STATE OF WASHINGTON  
DEPARTMENT OF ECOLOGY

October 23, 2019

**Re: Further Action at the following Site:**

- **Site Name:** Independent Metals Storage Lot
- **Site Address:** 703 S. Monroe Street, Seattle 98108
- **Facility/Site No.:** 21489
- **Cleanup Site ID No.:** 12299
- **VCP Project No.:** NW3223

**Figure 2**  
Site Plan with Boring and Sampling Locations

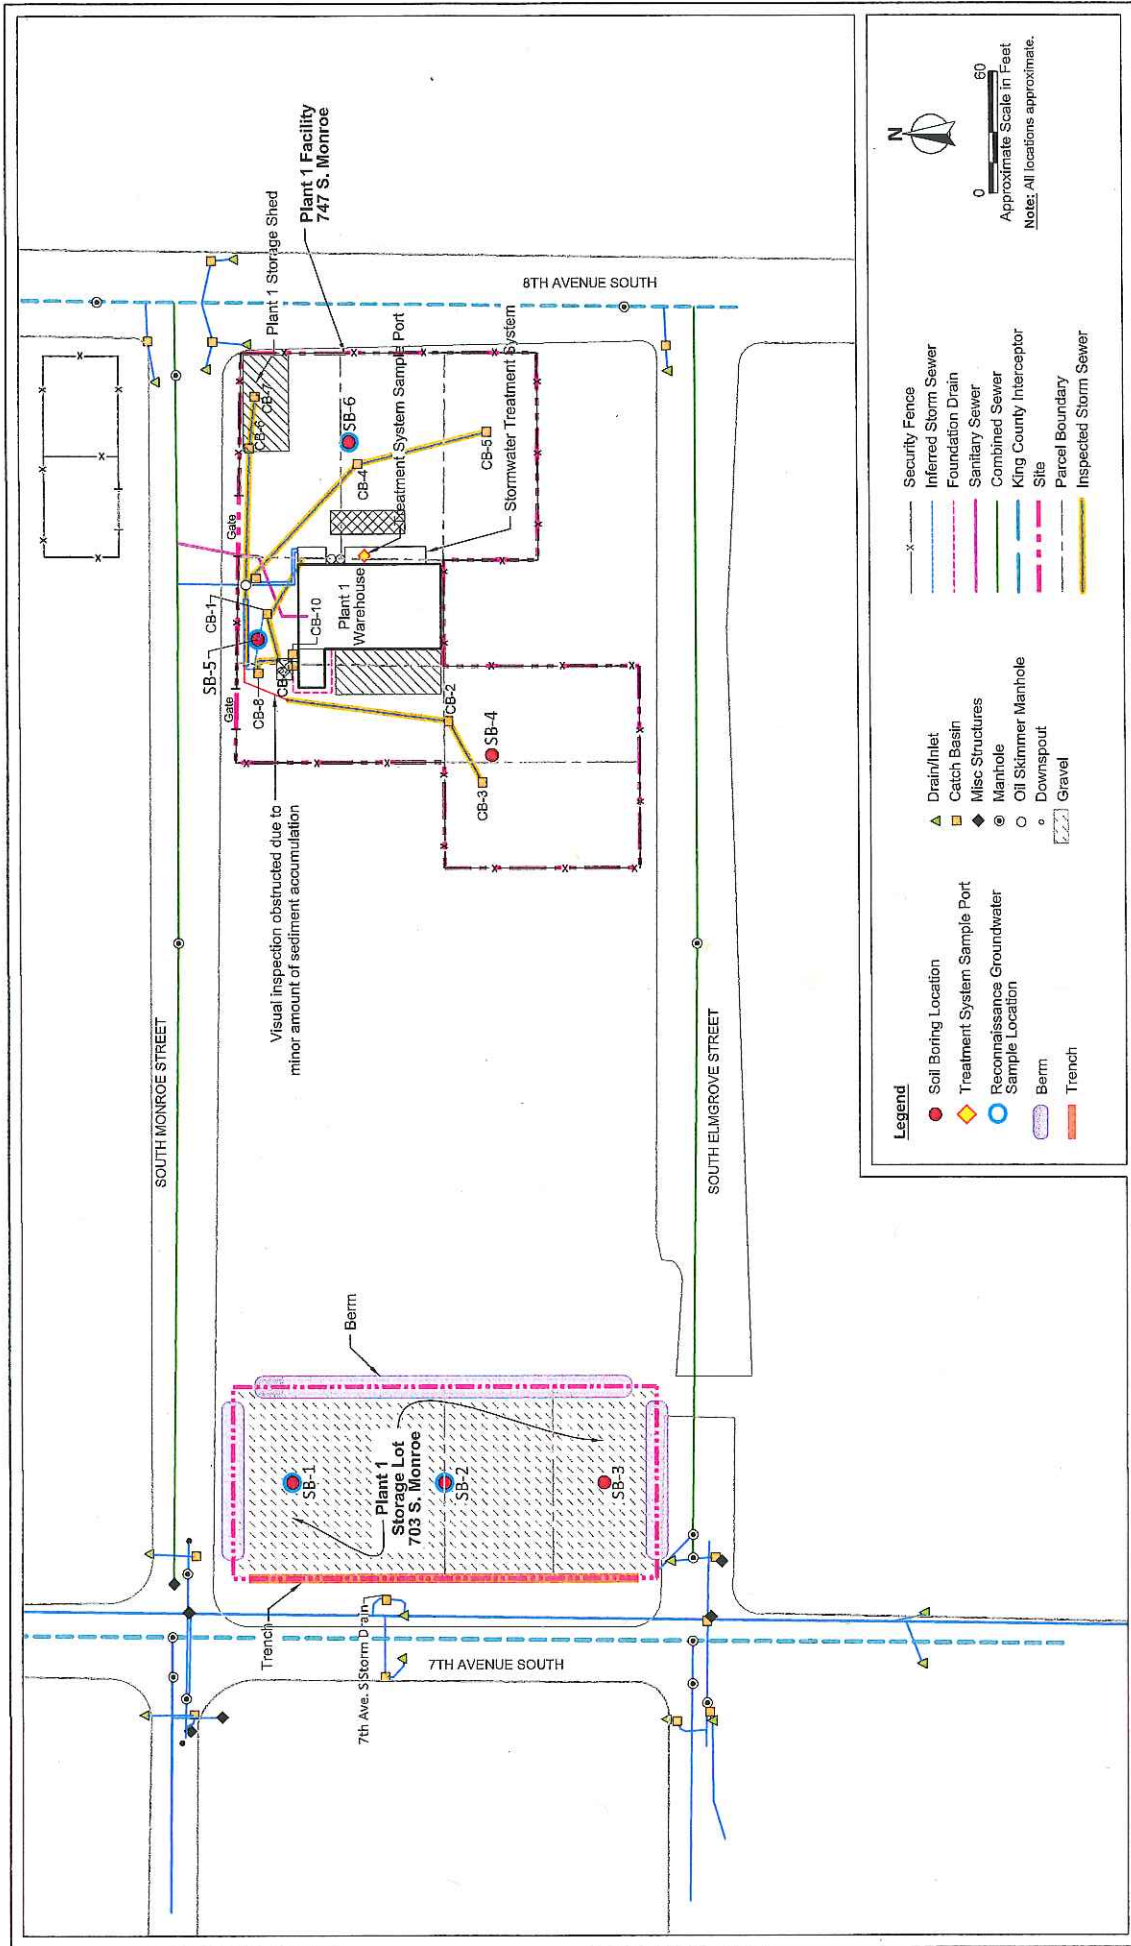
- In June 2015, Pacific Crest conducted a PHII, including the advancement of three soil borings to a maximum depth of 28-feet below ground surface (bgs). Soil and groundwater samples collected during this PHII did not exhibit any contaminants of concern (CoCs) above the respective MTCA Cleanup Levels (CULs) or laboratory method detection limits (MDLs). The location of these borings is illustrated in Figure 2, (Pacific Crest, November 2017).

In June 2015, Pacific Crest advanced three soil borings on the Site (Plant Once Storage Lot). Temporary well points were established in two of the three soil borings. Pacific Crest reportedly did not detect CoCs above the respective MTCA CULs in any of the soil and groundwater samples (Pacific Crest, November 2017). Locations of these soil borings are depicted in Figure 2.

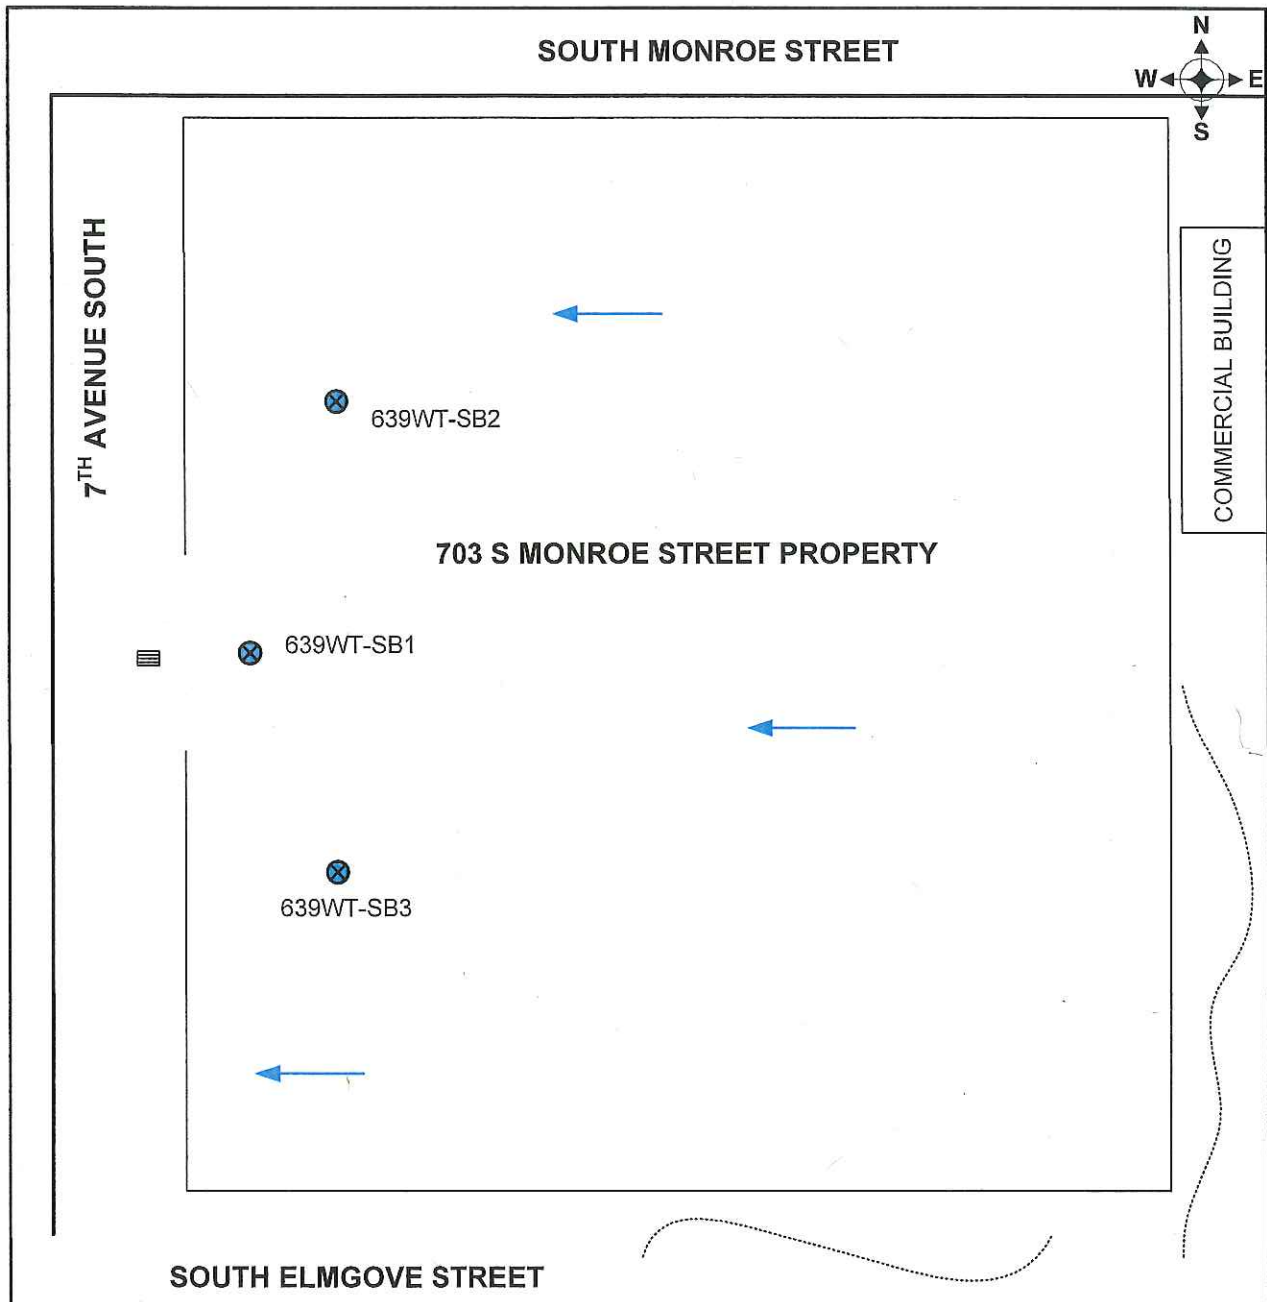
In September 2018, GO Spectrum advanced three soil borings to approximately 20-foot bgs. The location of the borings is depicted in Figure 3. GO Spectrum encountered groundwater at approximately 6.5-foot bgs in all three borings. Groundwater is under unconfined, perched conditions. GO Spectrum asserts the groundwater flow direction and gradient are relatively flat, with a slight topographic slope to the west. The only CoC exhibiting detections above the respective CUL is Arsenic in groundwater. Arsenic concentrations ranged from 11 to 56 µg/L, above the applicable CUL of 5 µg/L (GO Spectrum, September 2018). GO Spectrum postulated the source of arsenic originated from leached metals exposed to stormwater runoff, which consequently infiltrated into the subsurface. Independent Metals reportedly implemented structural and operational BMPs in an effort to decrease or eliminate metals contamination sources. Stormwater has not been sampled since 2013 (GO Spectrum, September 2018).

GO Spectrum has indicated an additional three MWs are necessary to definitively characterize the Site. In addition, Ecology is requesting an additional stormwater sample, to verify the effectiveness of the aforementioned BMPs.
